Seat Harness Routing (Non-Swivel)
 VN, VHD, VAH

FSB 375-010, Seat Harness Routing (Non-Swivel)

(March 2014)

W3088546

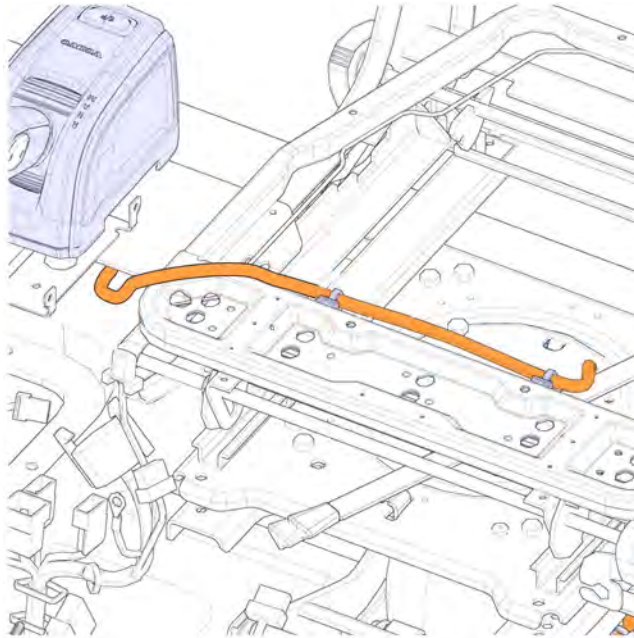
- 4 Look for chafed wires under seat base. Reuse harness if undamaged. If damaged repair as necessary.

W3076417

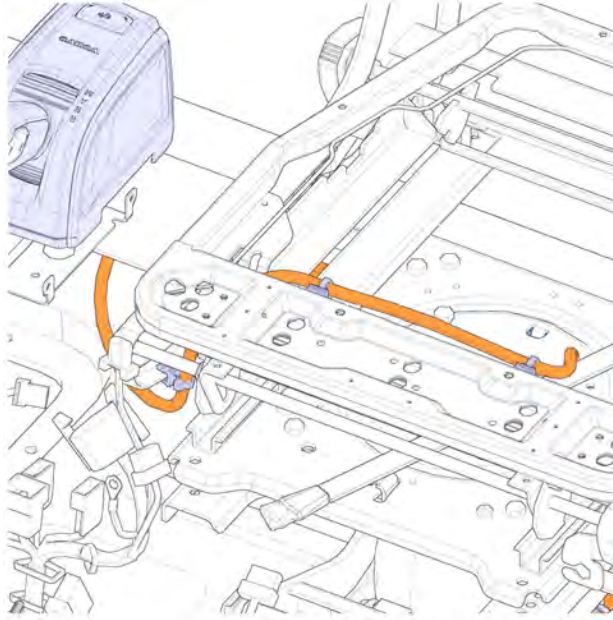
- 5 Flip seat cushion up and loosely install and cable tie the shifter harness along the new path for routing and clipping.

W3076420

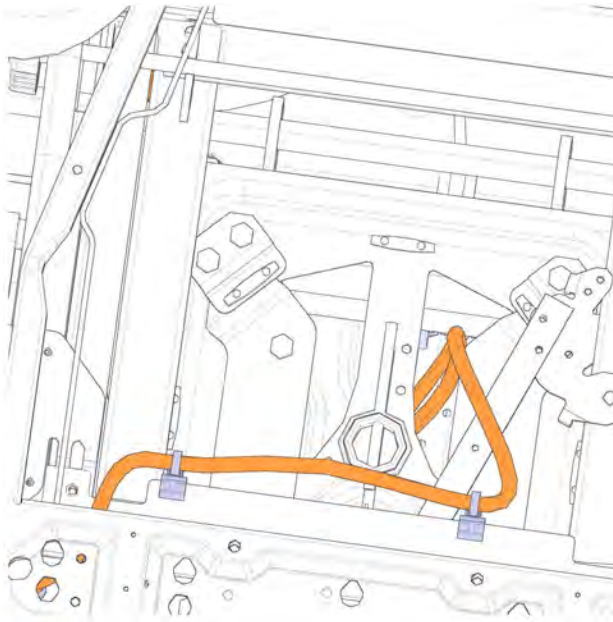
Cable Tie with Horizontal Edge Clip # 21096682, Qty 2

W3076419

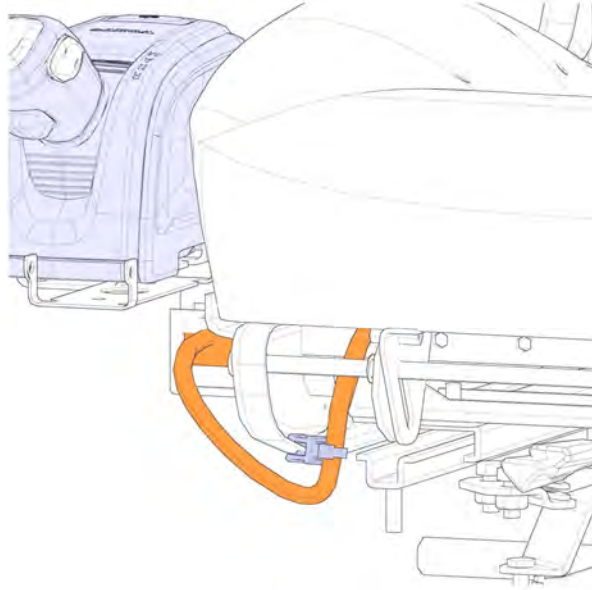
- 6 Secure the shifter harness by cinching all the cable ties until the corrugated loom is lightly snug.

Cable Tie with Vertical Edge Clip # 25375492, Qty 1

Note: Do not over tighten the cable ties, otherwise the wires and loom will become damaged.
